FILE NO.: Z-10069

NAME: Our Lady of the Holy Souls Catholic Church – Parking Lot – PD-O

LOCATION: 1015 N. Tyler Street/1016-1020 N. Harrison Street

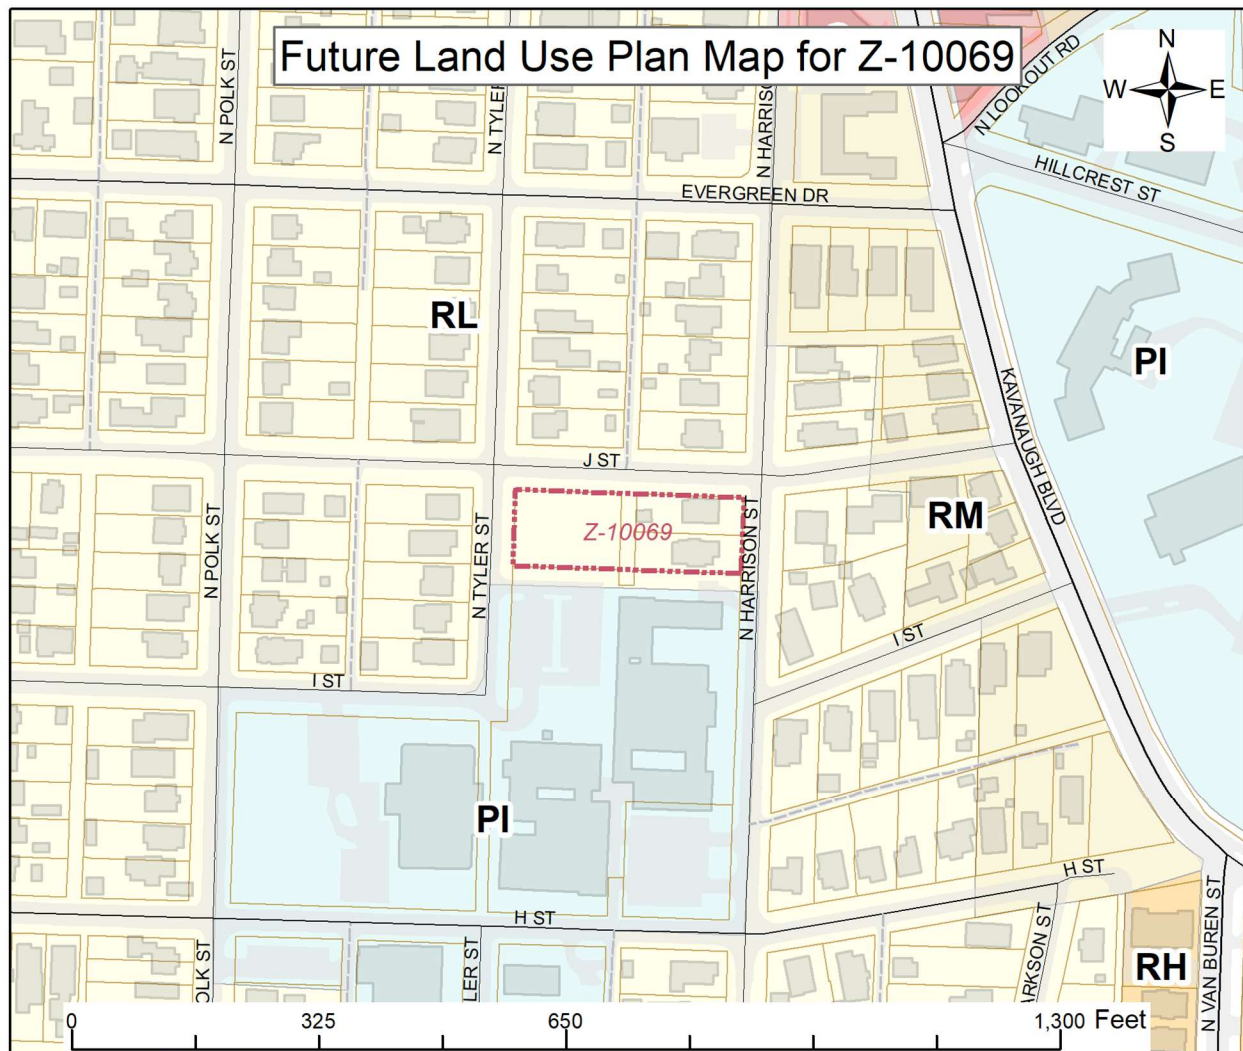
The property is located within the Hillcrest Design Overlay District. Section 36-434.15, B.3. of the City's Zoning Ordinance (Hillcrest DOD regulations) states that no parking is to be located within the front yard setback of lots. Portions of the proposed parking lot will be located within the front 25 foot setback of the lots fronting N. Harrison Street and N. Tyler Street. As such, the ordinance requires that the parking lot be reviewed through the planned development rezoning process and not a conditional use permit, which would typically be required.

Two (2) points of ingress/egress are proposed for the parking lot: An eighteen (18) foot wide driveway extending from "J" Street to the north and a twenty-five (25) foot wide driveway extending from N. Harrison Street.

The applicant proposed developing the parking lot in two (2) phases:

- The Phase I expansion will include 33 total parking spaces within the west half of the property.

ADA parking spaces will be provided within the existing parking area to the south.

- The Phase II expansion will include twenty-seven (27) additional parking spaces within the east half of the property, and removal of two (2) residential structures.

Staff recommends approval of the PD-O rezoning, subject to compliance with the comments and conditions outlined in paragraphs E and F, and the staff analysis, of the agenda staff report.
